6200000 GROUNDING AND LIGHTNING PROTECTION  
COMMENTS FROM INTERNAL/INDUSTRY REVIEW

6200000  
All Jobs

**SECTION 620  
TRAFFIC CONTROL SIGNAL AND DEVICE  
INSTALLATION-GROUNDING AND LIGHTNING PROTECTION**

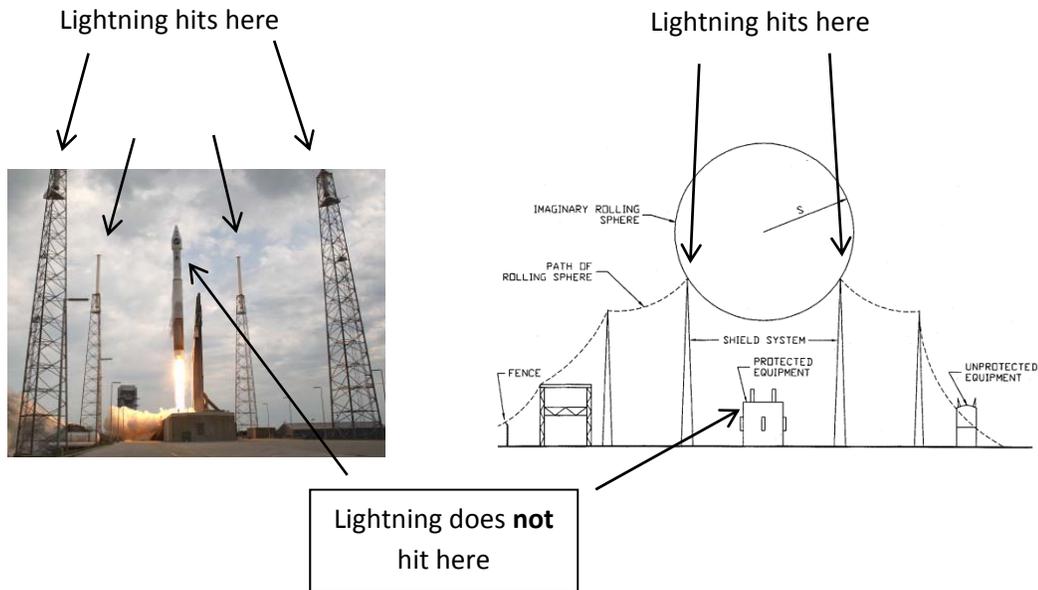
- If the intent of the LPS is to provide a sacrificial lightning ‘attachment location’ to protect the pole, but not necessarily the electronic equipment, then maybe leave everything as is. Ditto, if there are liability concerns as following established LPS standards offers legality advantages.
- However, if the intent of the LPS is to fully protect delicate electronic equipment, I contend this is a costly and nearly futile exercise based on the following reasoning:

Two objectives of LPSs are to force current where we want it to go and prevent the development of hazardous potential differences. I contend that air terminals and down conductors within feet or inches of sensitive electronics are not where we want current to go. It makes more sense to keep those currents as *far away* as possible. This would apply to pole-mounted CCTVs, Dynamic Message Signs, Vehicle Detection equipment, etc. I am not convinced that LPS standards focus on protecting sensitive electronics, rather on life safety foremost. (Although, this is well worth additional debate.)

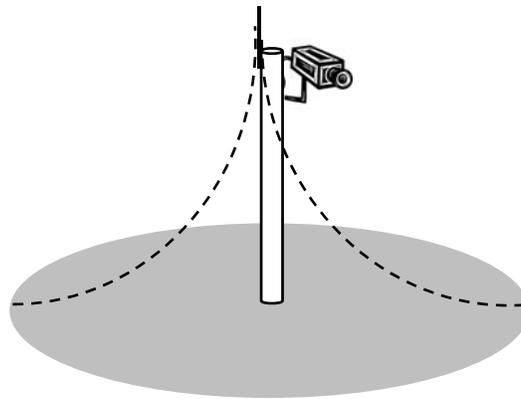
This next topic is also very debatable: There is rationale that LPSs do not attract lightning, and/or do not increase the likelihood of a direct strike. Consequently, including an LPS on an ITS pole will not increase the probability of direct strikes. (There may be conditional wording, semantics or variations on this theme.)

I contend that LPS standards have mature algorithms recommending the height and location of air terminals such that they create spheres of protection below them. From a historical perspective, *within the geographical sphere(s) of protection*, the only place where lightning will attach is the air terminal. Consequently, I believe there *is* evidence that air terminals attract lightning. (James Clerk Maxwell of 'Maxwell's Equations' fame postulated the same in 1876.) A flaw in my logic is that lightning could attach regardless of whether or not an LPS exists. In that case, there is no risk in eliminating the LPS, or an outside copper down conductor theft risk. Note that a tubular metallic pole has less inductance than the round down conductor and serves as a better conductor. If the down conductor is inside the metallic pole, I believe there is an effect much like coaxial cable where surge current divides unequally and propagates at different speeds due to inductive effects, causing weird behaviors. If eliminating air terminals, LPS standards suggest that 3/16" thick metal is sufficient to displace the air terminals.

**Possible pole / lightning mast implementation:**

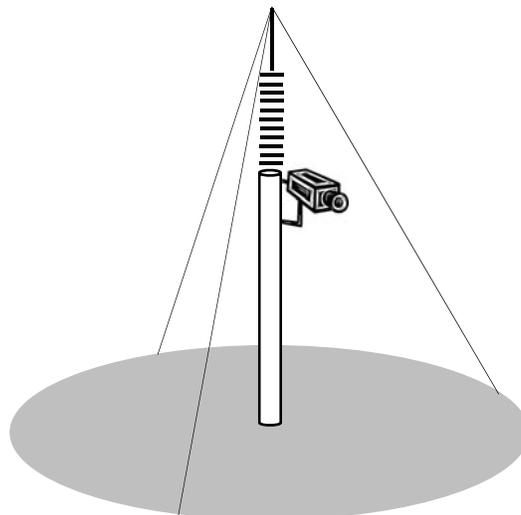
Existing metal pole with a ~500kV utility transmission line insulator between the pole and an air terminal. Lightning hits the air terminal and goes down the ground wires, *not* down the tower. Keeps lightning as far from the load as possible without building a separate lightning mast. (Shuttle tower did something very similar. People did not notice the conductor lines, but they are there.) Note probable mowing challenges.

This might be ugly enough to *scare* lightning away!

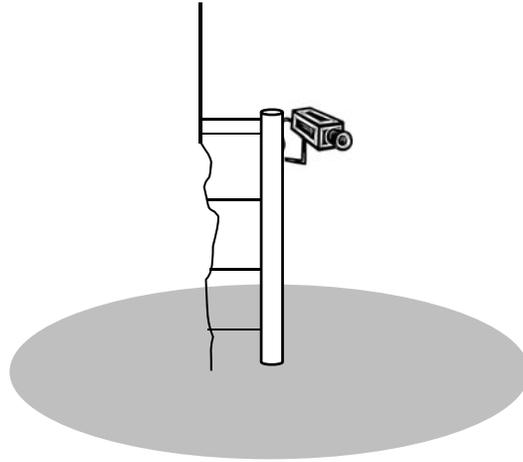
A variation on this could be an isolated air terminal and down conductors off the side of the metal pole. (I suspect someone has already looked at this.) As above, the intent is to try to prevent the pole from being energized by the lightning. If the pole becomes energized, then there is a substantial risk of flashover between the metallic pole and other electrical equipment. If the pole becomes energized, I am not convinced the LPS provides value.
